APPLICATION NO.	FILING DATE	FIRST NAMED INVENTOR	ATTORNEY DOCKET NO.	CONFIRMATION NO.
09/848,819	05/03/2001	Richard T. Allen	ACS 57527	8480

## Office Action Summary

## **DETAILED ACTION**

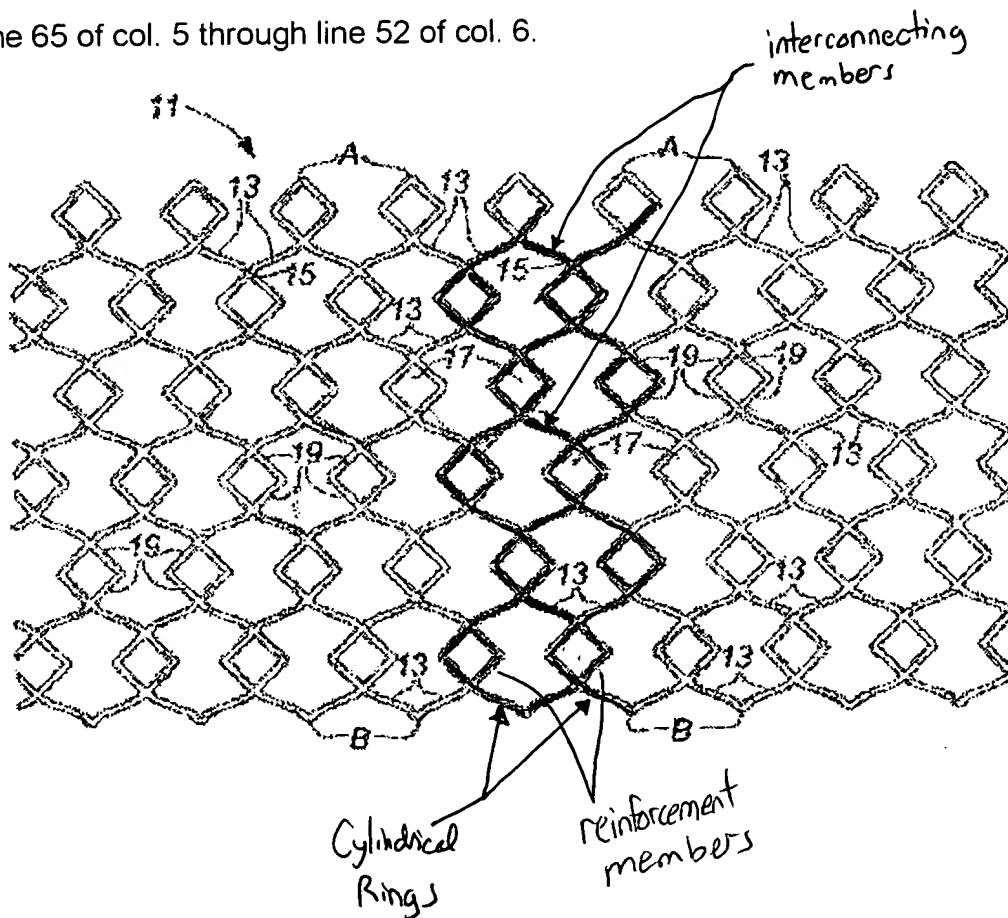
2. Claims 1,2,6,11,15-19, and 21 are rejected under 35 U.S.C. 102(e) as being anticipated by Milo US PN 6,206,911.

See figure 1 inserted below specifically showing location of the cylindrical rings, reinforcing members, and interconnecting members in figure 1. Also see lines 26-54 of col. 3 and line 65 of col. 5 through line 52 of col. 6.

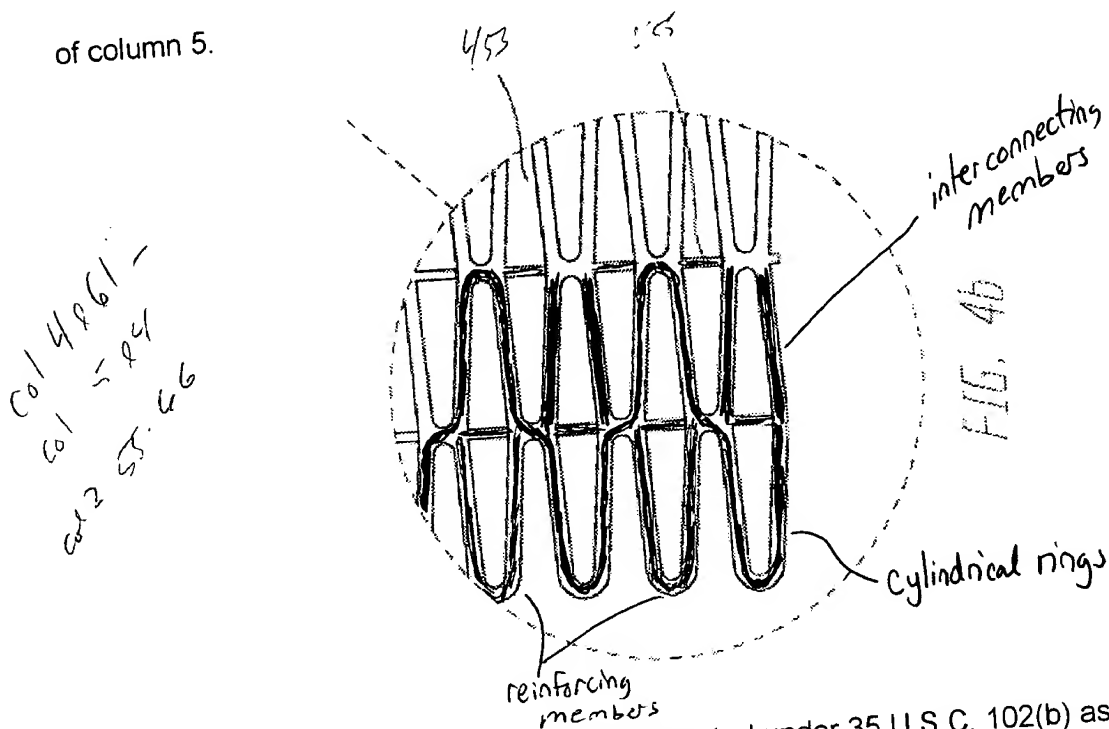
3. Claims 1,2,4,10,11,15,16,18,19, and 21 are rejected under 35 U.S.C. 102(e) as being anticipated by Killion US PN 5,868,781.

See figure 4b below specifically showing location of the cylindrical rings, reinforcing members, and interconnecting members in figure 4B. Also see lines 16-27 of column 5.

【図11】

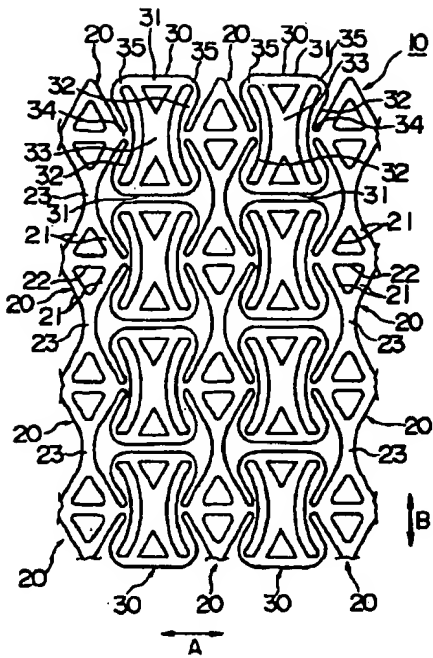
4. Claims 1,4,6,10,11,18, and 19 are rejected under 35 U.S.C. 102(b) as being anticipated by Hiroyuki et al. JP 10201856 A.

Hiroyuki et al. discloses a stent in figures 11-12 meeting the structural limitations of claims 1,4,6,10,11,18, and 19. See the attached figures 11-12 showing specific locations of the cylindrical rings, interconnecting members, and reinforcing members.
